Counter Proposal and Rationale Regarding OICA Font for Tyre Identification Proposal (TYREGTR-12-03)

Tyre Industry proposed changes (red and strike-through) (14 February 2012)

Working Paper N° : TYREgtr-12-03
(OICA) Font for Tyre Identification
Number in draft gtr

Below is a picture of a currently produced Tyre.

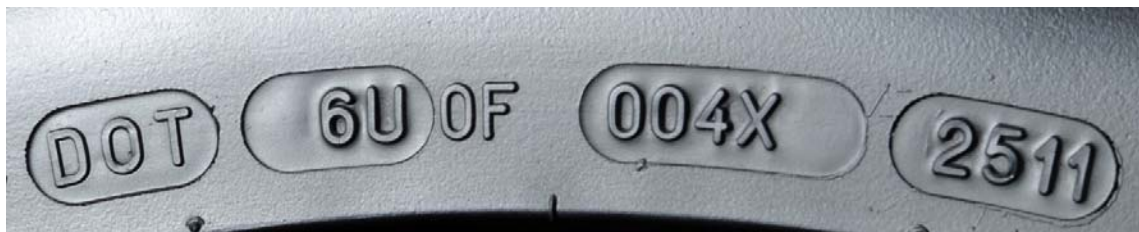
Other features of current tyre markings (such as the outline of the mold insert) may or may not be tolerated by optical readers. If OICA wishes to pursue this application to tyres, a full study should be undertaken. Some of the questions which should be explored include:

Question: Does the 'optical character recognition' require a specific letter or number spacing? Does it comply with current FMVSS letter spacing requirements?

Question: As you can see in the example below, both engraving and stamping are being used. Are these acceptable for OCR reader?

Question: We also use plaquettes for most of the marking, which induces a line above and between the letter/number information. Would these lines confuse an OCR reader?

Question: Will a prefix and suffix "symbol" confuse an OCR reader? For example, it is possible to place "DOT" in front of the TIN, and as a suffix, the Canadian Maple Leaf.
